Amendments to the 02 series of amendments to Regulation No. 117 (Tyre rolling noise, wet grip adhesion and rolling resistance)

It is proposed to include wet grip adhesion provisions for C2 and C3 tyre categories.

Figure 1 — Nomenclature explanation related to grip index of the tyre

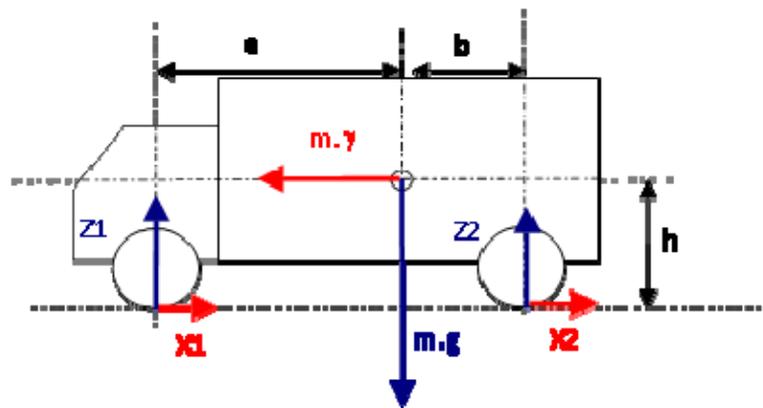
The Wet grip index represents the relative performance of the candidate tyre compared to the reference tyre. The way to obtain it depends on the test configuration as defined in section 6.5.1. The wet grip index of the tyre is calculated as reported into Table 3:

<p>Configuration C1: candidate tyres on both axles</p>	$\text{Wet Grip Index} = \frac{BFC(T)}{BFC(R)}$
<p>Configuration C2: candidate tyres on front axle and reference tyres on rear axle</p>	$\text{Wet Grip Index} = \frac{BFC(T)[a + b + h.BFC(R)] - a.BFC(R)}{BFC(R)[b + h.BFC(T)]}$
<p>Configuration C3: reference tyres on front axle and candidate tyres on rear axle</p>	$\text{Wet Grip index} = \frac{BFC(T)[-a - b + h.BFC(R)] + b.BFC(R)}{BFC(R)[-a + h.BFC(T)]}$

Where:

G centre of gravity of the loaded vehicle

"a": horizontal distance between front axle and centre of gravity of the loaded vehicle (m)

"b": horizontal distance between rear axle and centre of gravity of the loaded vehicle

"h": vertical distance between ground level and centre of gravity of the loaded vehicle (m).

N.B. When "h" is not precisely known, these worst case values shall apply: 1,2 for configuration C2, and 1,5 for configuration C3
